STAFF REPORT: FEBRUARY 10, 2021 MEETING

APPLICATION NUMBER: 21-7084

ADDRESS: 93 -109 SEWARD AVENUE

SCOPE OF WORK: DEMOLISH PARKING STRUCTURE, WINDOW REPLACEMENT, ASSORTED EXTERIOR MODIFICATIONS

AS100

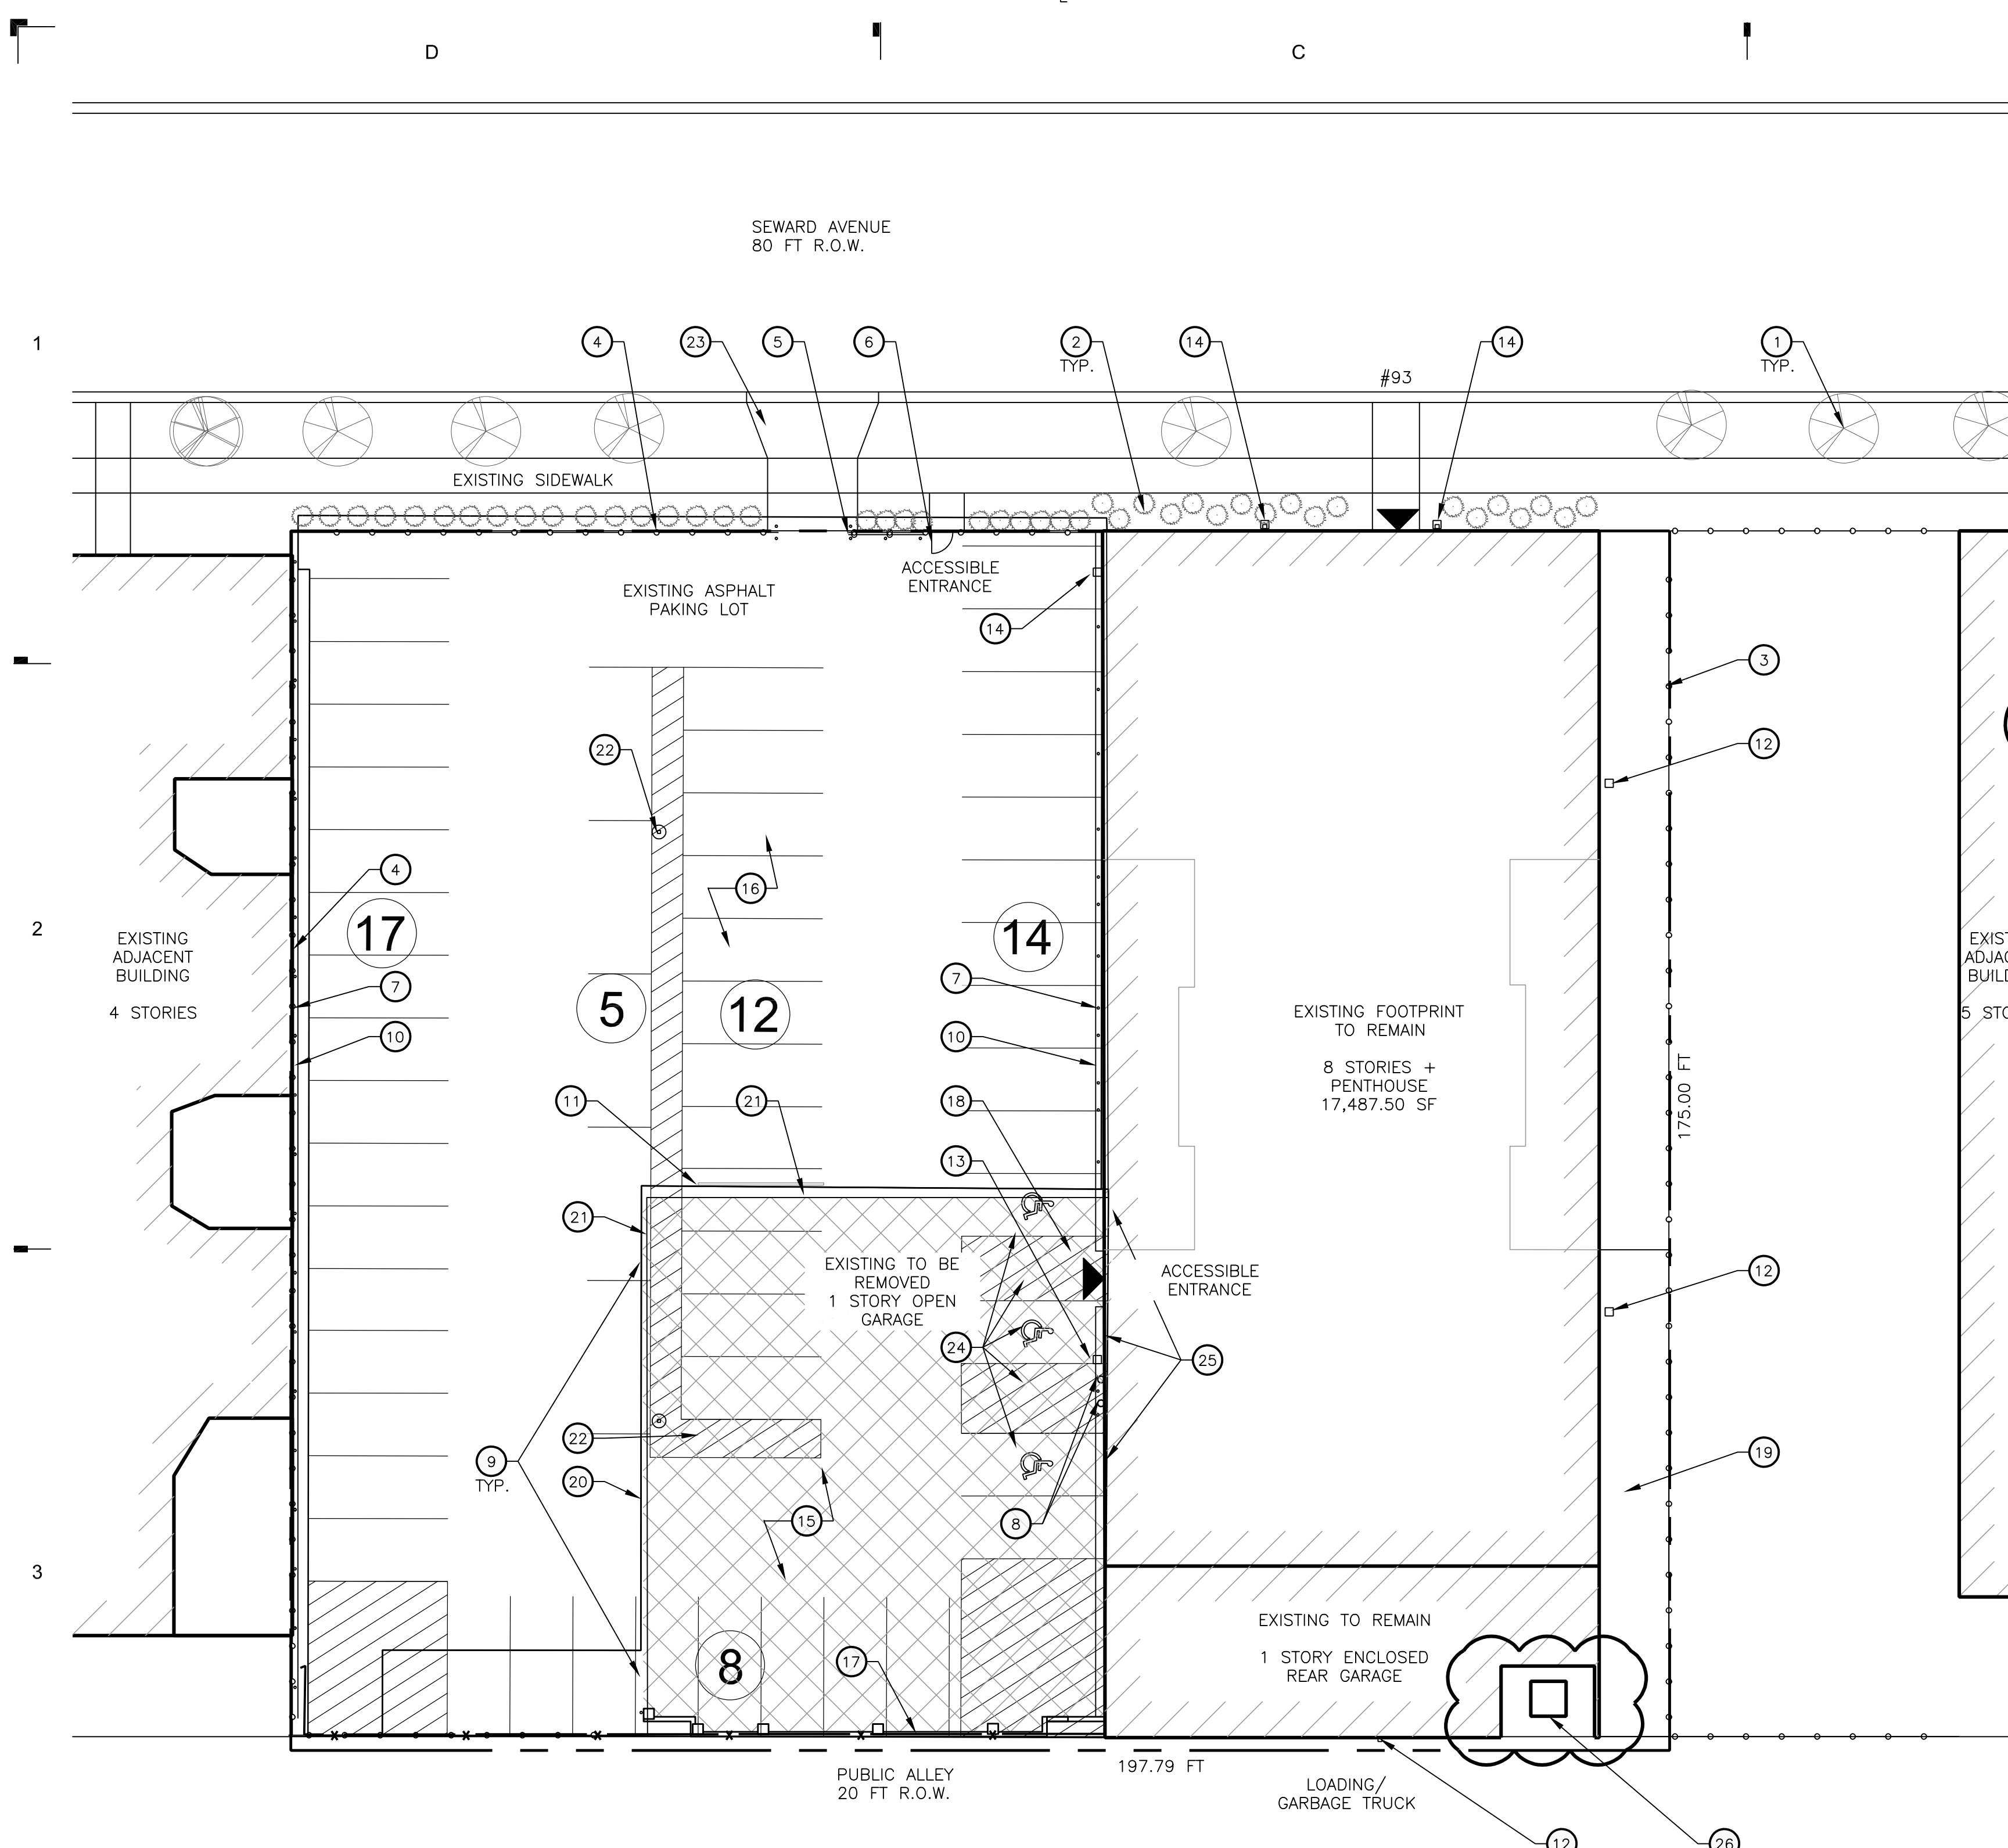
- Specs for the replacement fence and gate have not been submitted, however, based on the plan, the applicant is proposing to **replace the existing 6' tall, black aluminum fence around the parking with a new 7' tall aluminum picket fence, painted black**. This does not conform to HDC fence **guidelines**. Staff recommends the Commission approve this with the condition that the new fence does not exceed 6' tall along the Seward Avenue right of way.

- The applicant submits final details for proposed windows to show they conform with basis of design reviewed in this proposal prior to staff signing off on the permit.
- The fence along Seward Ave. does not exceed 6' in height and the applicant submits manufacturer specs for the proposed fence and gate prior to HDC staff signing off on permit.
- The applicant submits to staff documentation of masonry "test patches" prior to commencing full scale cleaning of brick and limestone, in accordance with **HDC masonry cleaning guidelines**.
